October 28, 2015

SUBJECT: Comments on the Bay Delta Conservation Plan Partially Recirculated Draft Environmental Impact Report/Supplemental Draft Environmental Impact Statement

SUBJECT: Comments on the Bay Delta Conservation Plan and Environmental Impact Report/Environmental Impact Statement

Figure 44. Alt 4 North Delta Diversion Versus South Delta Diversion for July, August, and September

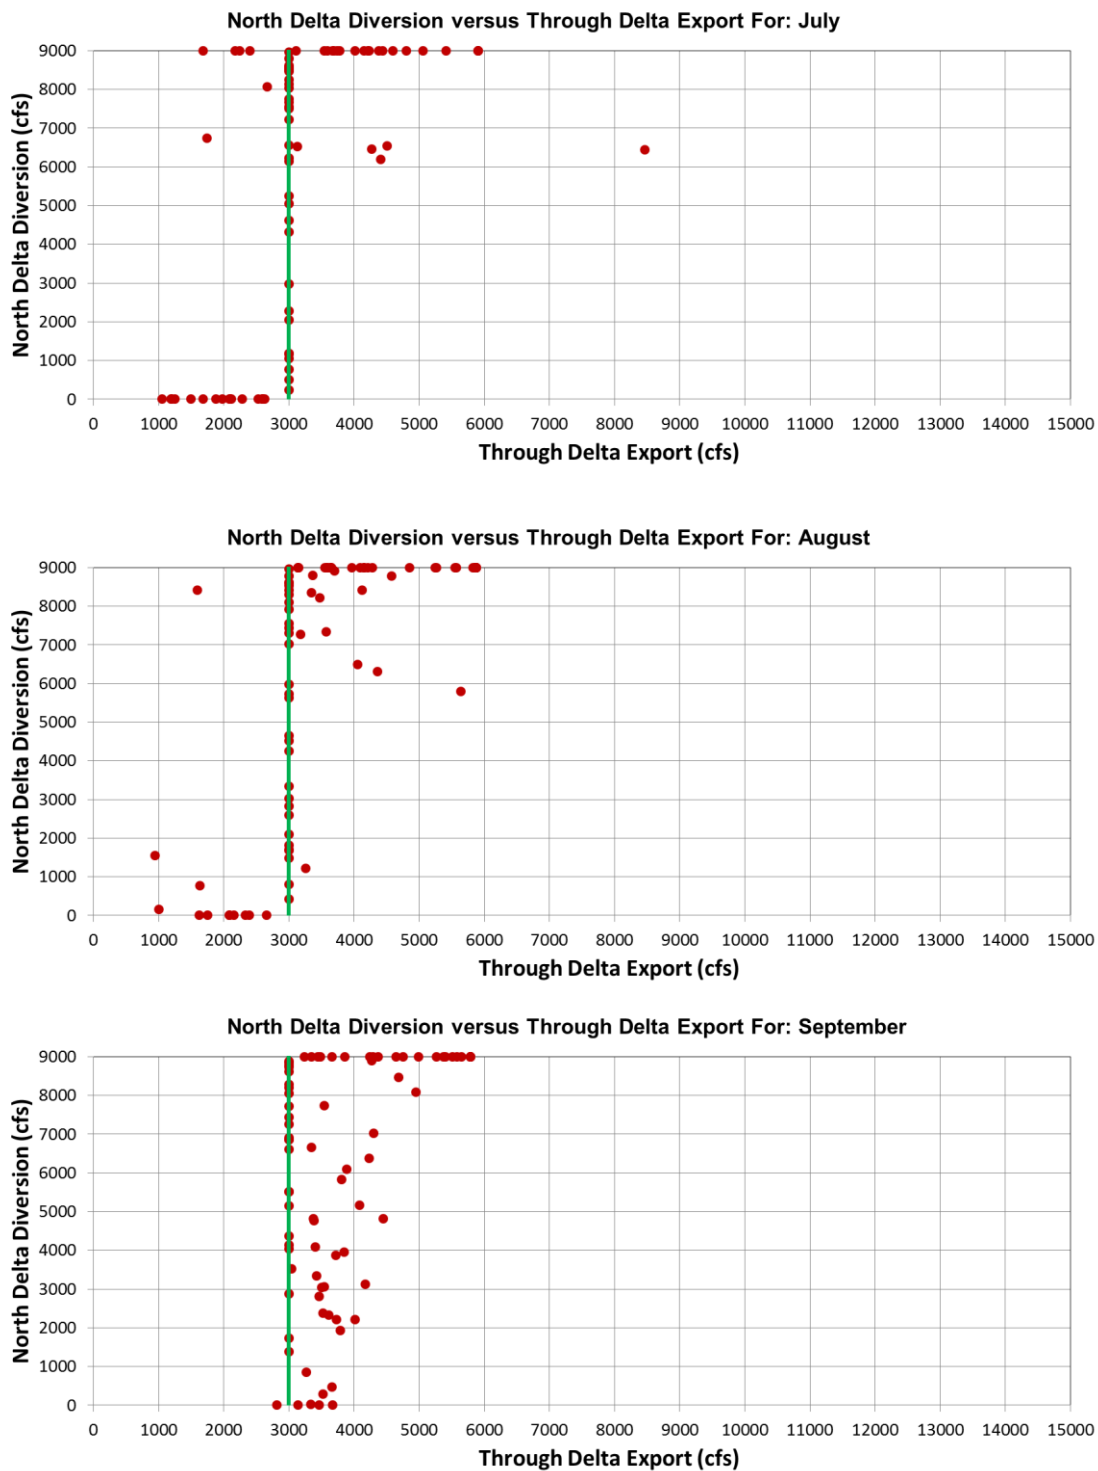
Figure 44 contains modeling results from Alt 4 for July, August, and September that plot NDD against SDD (Through Delta Export). There are many occasions when SDD are 3,000 cfs, which is due to criteria specifying that SDD during this time period need to be at least 3,000 cfs prior to diverting at the NDD facility. Although there are about six occurrences in July and three in August where the model did not satisfy this criterion, this issue has not yet been addressed for this modeling effort.

Figure 61. Sacramento River below Hood

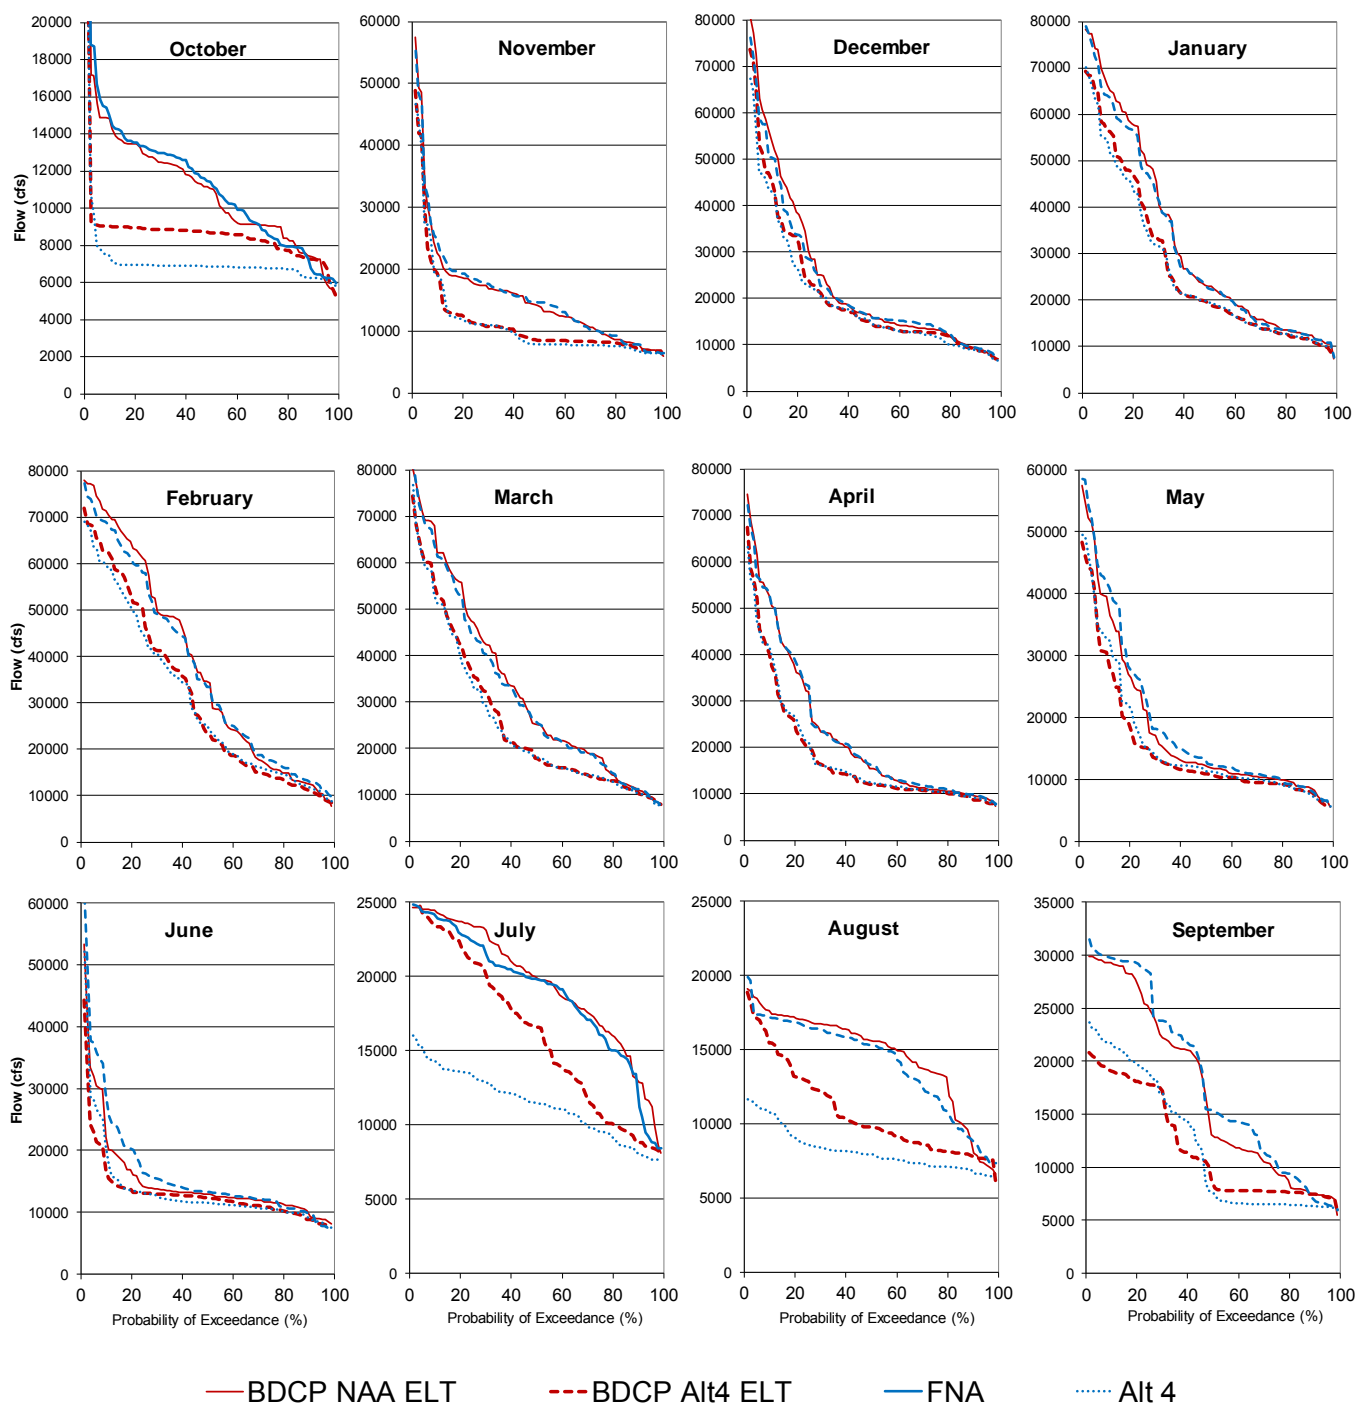
Figure 61 contains monthly exceedance probability plots for Sacramento River below the NDD for the following scenarios: 1) BDCP NAA-ELT, 2) BDCP Alt 4-ELT, 3) independent modeling FNA, and 4) independent modeling Alt 4. The most significant differences in flow changes occur in October, July, August, and September. Changes in Sacramento River flow entering the Delta are a key indicator of changes in interior Delta flows, water levels, and water quality.

In the independent modeling September flows are reduced by about 6,100 cfs while BDCP modeling shows a reduction of about 5,300 cfs. The independent modeling shows Sacramento River flow entering the Delta to be about 7,000 cfs 50% of the time, BDCP modeling show Sacramento River flow is about 8,000 cfs 50% of the time.

Figure 1: Reverse Flow Events per Year with Advective Transport Exceeding 0.9 Miles for DWR Modeling Studies, 1974-1991 Hydrology.

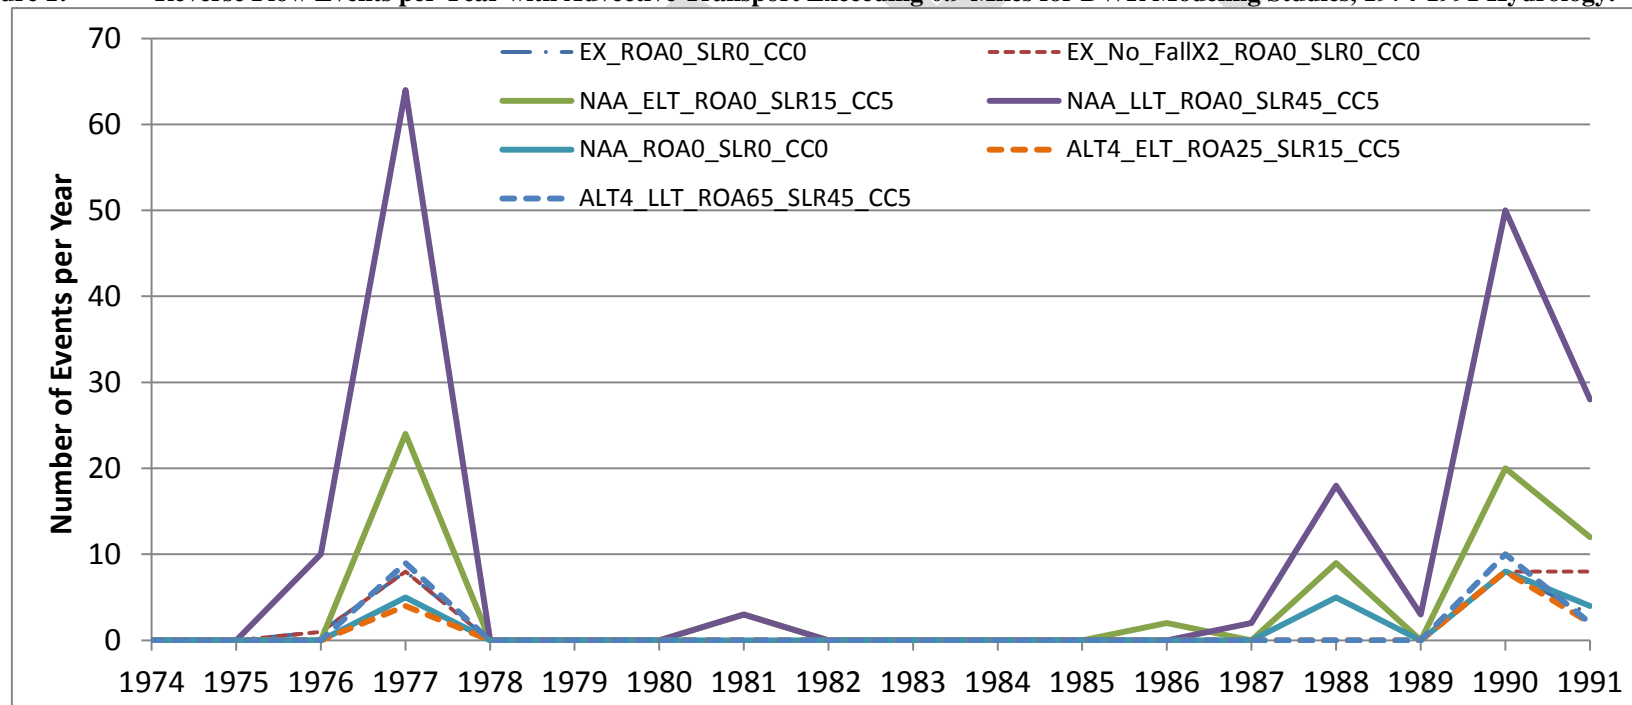
- DWR DSM2 model output was provided for each of the seven simulations listed in Table 1. Model results provided spanned October 1, 1974 through September 20 1991 on 15-minute intervals. Table 3 presents the number of reverse flow events with advective transport exceeding 0.9 miles that would cause a shutdown of FRWP for each of the seven DWR model simulations. Figure 1 shows the number of reverse flow events per year over the hydrologic period simulated.

Figure 2: Reverse Flow Incidents per Year with Advective Transport Exceeding 0.9 Miles for MBK Modeling Studies, 1921-2003 Hydrology.

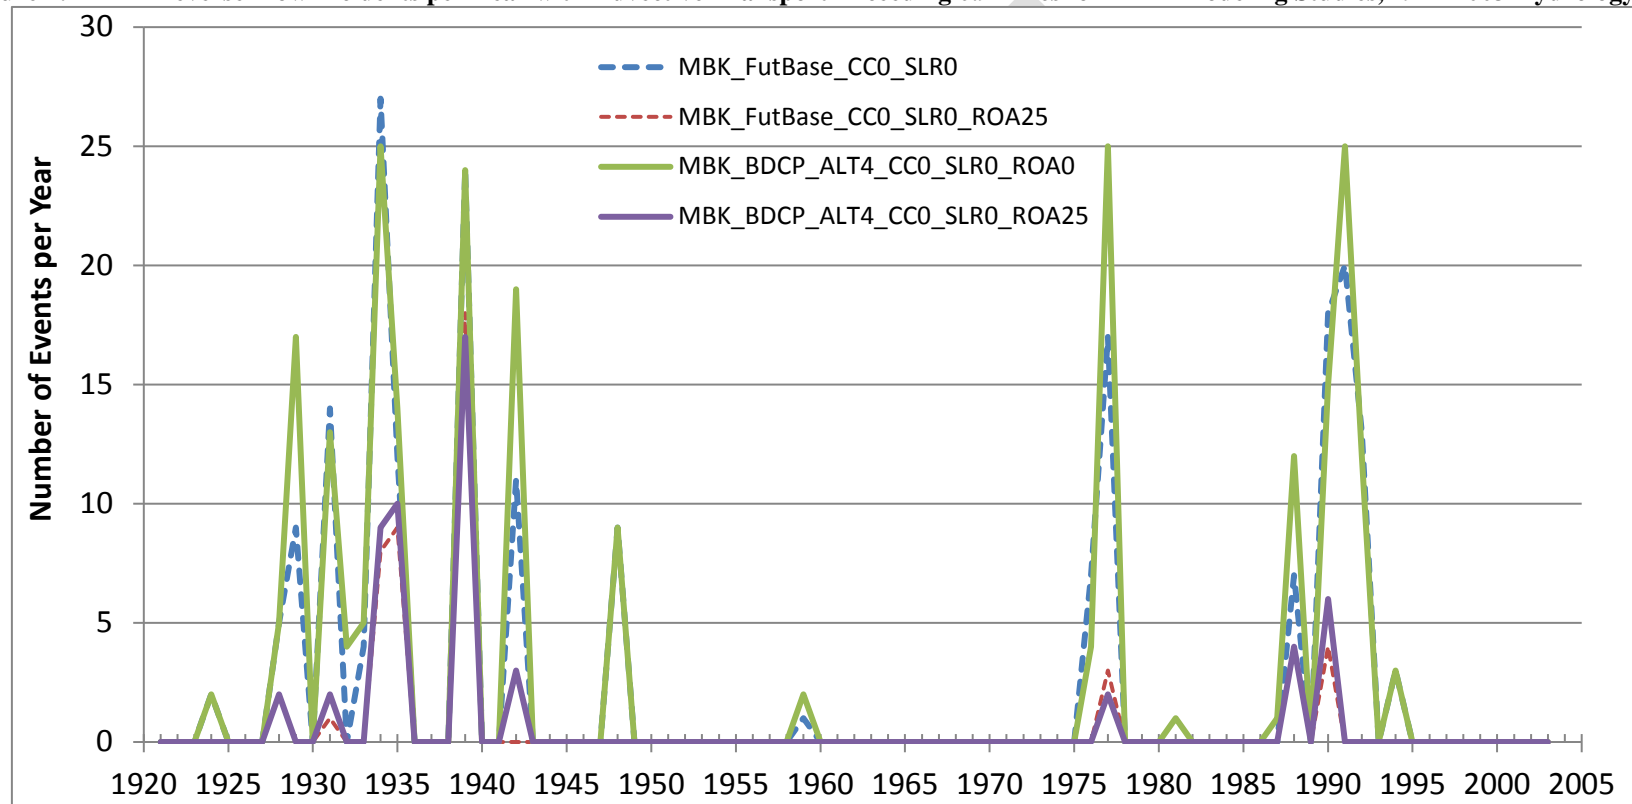
- Additional modeling performed by CCWD simulated the full hydrologic period that was simulated with Calsim2²⁵. This modeling provided additional clarifying information regarding the effect of the two components of the project isolating the effect of restoration. Four DSM2 model simulations were analyzed as described in Table 1. The number of reverse flow events for the full 83-year period of record and shorter 19-year period that would result in a shutdown of FRWA are presented in Table 4. The distribution of the number of reverse flow events per year is plotted in Figure 2.
